## Arlington Conservation Commission

**Date:** Thursday, April 4, 2024

**DEP #091-0356: Notice of Intent: Thorndike Place (Continuation from 3/21/2024).**

The Conservation Commission will hold a public hearing under the Wetlands Protection Act to consider a Notice of Intent for the construction of Thorndike Place, a multifamily development on Dorothy Road in Arlington. Continued Planting Plan / Habitat discussion including Invasive Species Management Plan and if time allows, continued stormwater discussion.

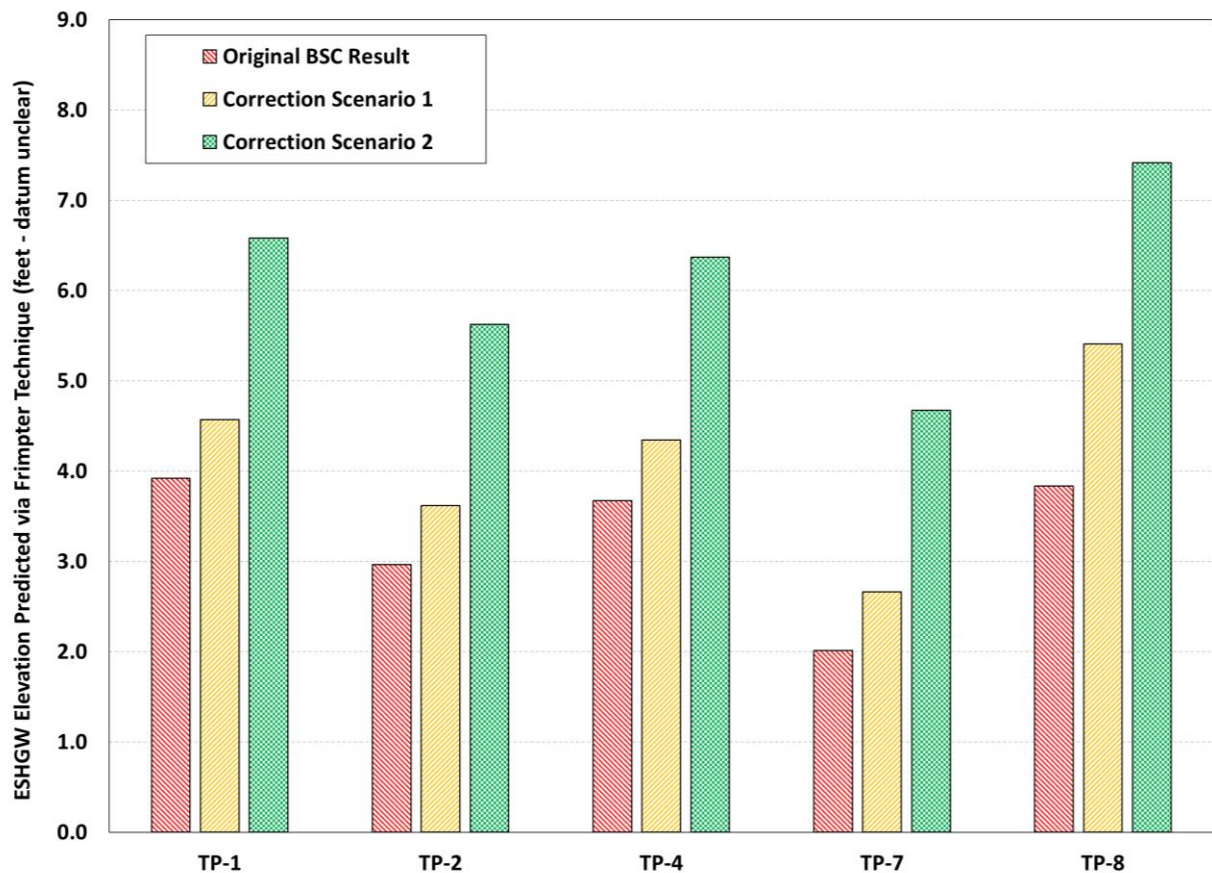
The effect of correcting the issues highlighted above is demonstrated by revising the Frimpter analysis under the following correction scenarios:

**Correction Scenario 1:** Address Issue 1 by using daily mean groundwater depths reported by the U.S. Geological Survey at index well MA-LTW on test pit completion dates, and address Issue 3 by making the Sr value consistent with the value used for other test pits (i.e., the outdated value of 4.2 feet).

**Correction Scenario 2:** Modify Correction Scenario 1 to include an Sr value of 7.1 feet based on the updated U.S. Geological Survey study.

The results produced under Correction Scenarios 1 and 2 are compared to the original results reported by BSC in the following figure:

As evidenced by the figure above, when the issues identified through MMA's review are addressed through revision, the Frimpter analysis predicts significantly and consequentially higher ESHGW elevations at all of the considered test pits. For most test pits, the degree of difference relative to the original BSC estimates indicates the resultant ESHGW elevation is more sensitive to (i.e., increases more due to) the  $S_r$  value basis highlighted under Issue 2 than the  $OW_c$  value basis highlighted under Issue 1. TP-8 displays a unique sensitivity profile due to the apparent  $S_r$  value error highlighted under Issue 3.

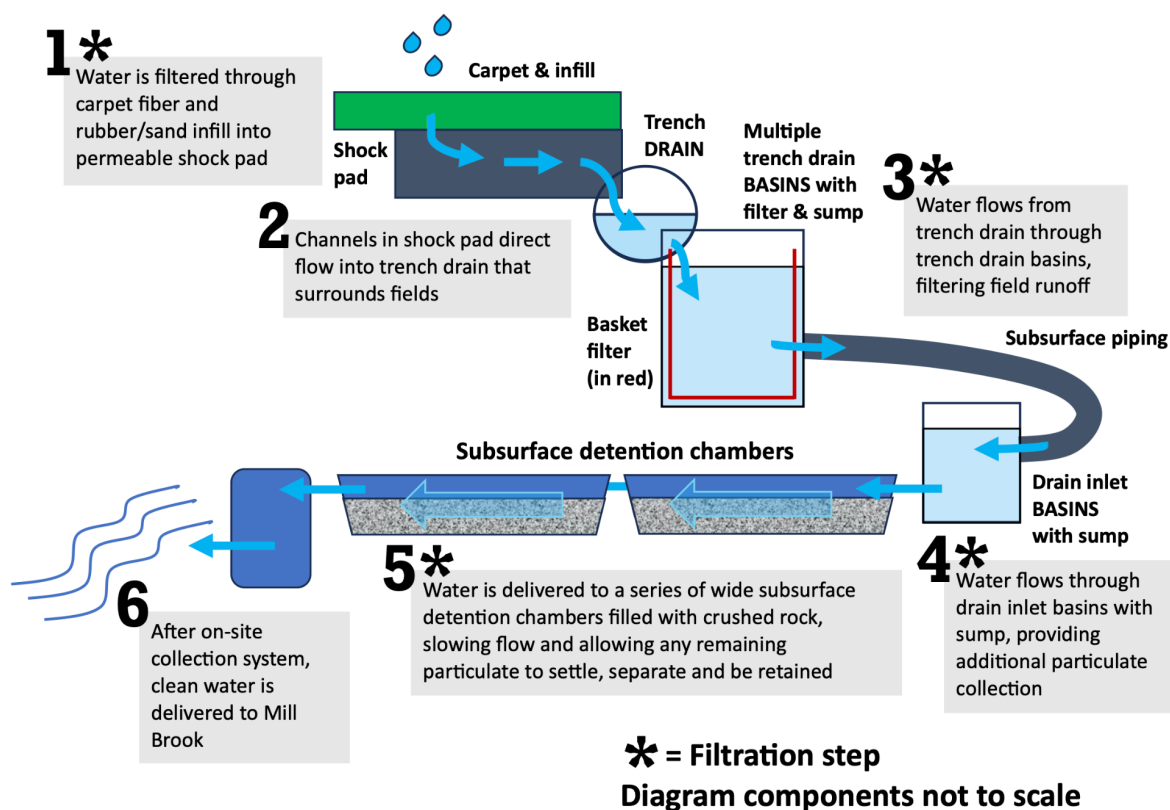
Conservation Commission members and members of the AHSBC design team extensively reviewed the design of the drainage system for the new fields in 2020. **The drainage system was an important factor in deliberations that led the Commission to conclude that the crumb rubber infill fields would not have a “substantial or cumulative impact” on the resource (Mill Brook) in 2020.**

**Following the August 2023 meeting with the Conservation Commission, the design team discussed ways to further strengthen the drainage system.** The result was the addition to the design of trench drain baskets, which will provide an additional filter to prevent the flow of turf infill into Mill Brook. The AHSBC looks forward to reviewing this added feature with the Conservation Commission on April 4, 2024.

The drainage system design, which has been purchased except for the trench drains, mitigates infill flow to Mill Brook through the following strategy:
